APPLICATION NO.	FILING DATE	FIRST NAMED INVENTOR	ATTORNEY DOCKET NO.	CONFIRMATION NO.
10/773,589	02/06/2004	Nokihisa Adachi	428291/0024 8964	
7590 08/12/2005			EXAMINER	
Lawrence Rosenthal			NGUYEN, PHONG H	
Stroock & Stro	ock & Lavan LLP			
180 Maiden Lane			ART UNIT	PAPER NUMBER
New York, NY 10038			3724

DETAILED ACTION

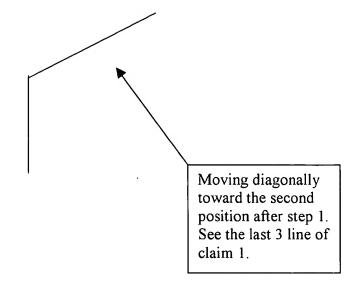
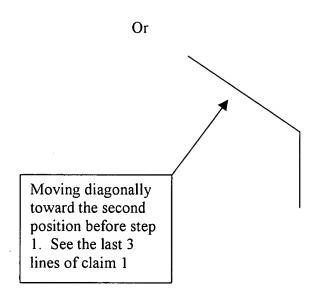
Regarding claim 1, the moving direction of the slitter and scorer is confusing.

Diagrams of the moving direction of the slitter and scorer being construed based on the language of claim 1 are different from Applicant's disclosure Figs. 10 and 11.

Step 1: vertical movement of the slitter and scorer

Step 2: diagonal movement of the slitter and scorer
